**FINAL DECISION DOCUMENT
FOR THE INTERIM RESPONSE ACTION
AT THE
COMPLEX DISPOSAL TRENCHES
ROCKY MOUNTAIN ARSENAL
APRIL 1990
CONTRACT NO. DAAA15-88-D-0022/0002
VERSION 4.0**

RESPONSE TO COMMENTS FROM THE EPA
ON THE PROPOSED DECISION DOCUMENT FOR THE INTERIM RESPONSE ACTION
FOR THE ARMY COMPLEX DISPOSAL TRENCHES

RESPONSE TO COMMENTS FROM SHELL OIL COMPANY
ON THE PROPOSED DECISION DOCUMENT FOR THE INTERIM RESPONSE ACTION
FOR THE ARMY COMPLEX DISPOSAL TRENCHES

Figure 2-2

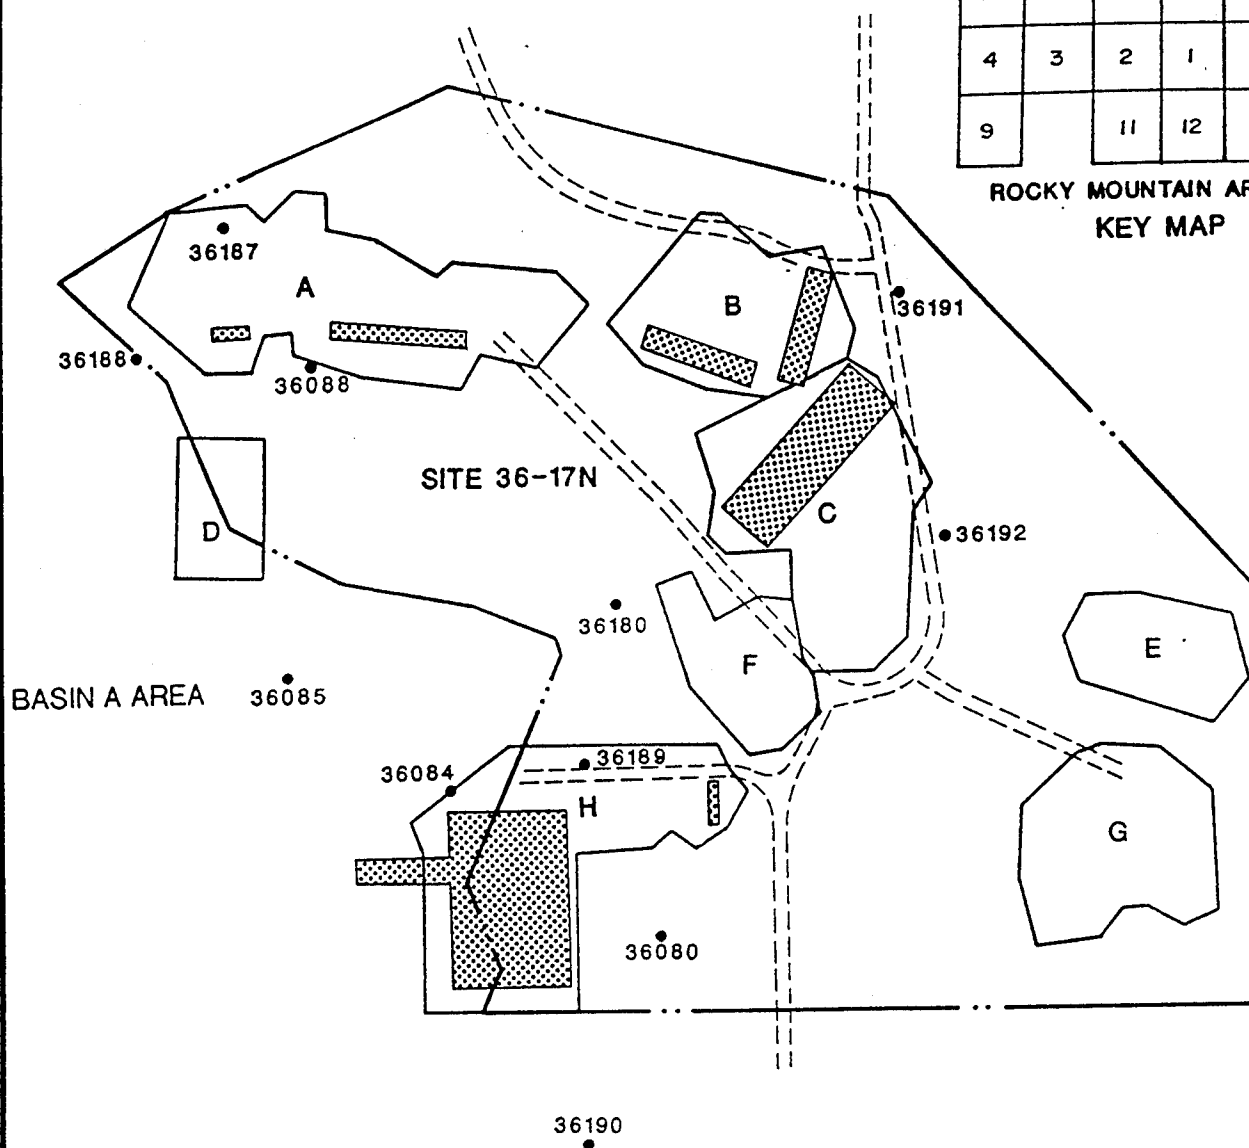
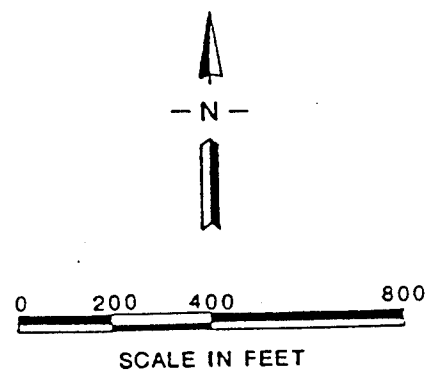
Comment 4: The shaded areas of Figure 2-2 need to be darkened or crosshatched to stand out clearly.

Comment 3: p. 2-4 Figure 2-2 - Location of Trenches in Site 36-17N - This figure appears to be generally lacking in information. Groundwater contamination data for the listed wells are not included, and a number of groundwater monitoring well locations (such as 36090, 36121, 36158, 36184, and 36185) are also omitted. Figure 2-2, or additional figures, should contain such data.

Response: The figure has been revised.

Response: Figure 2-3 has been added to show monitoring well locations. Appendix B was added to the Draft Final Decision Document and includes soil and groundwater contamination data.
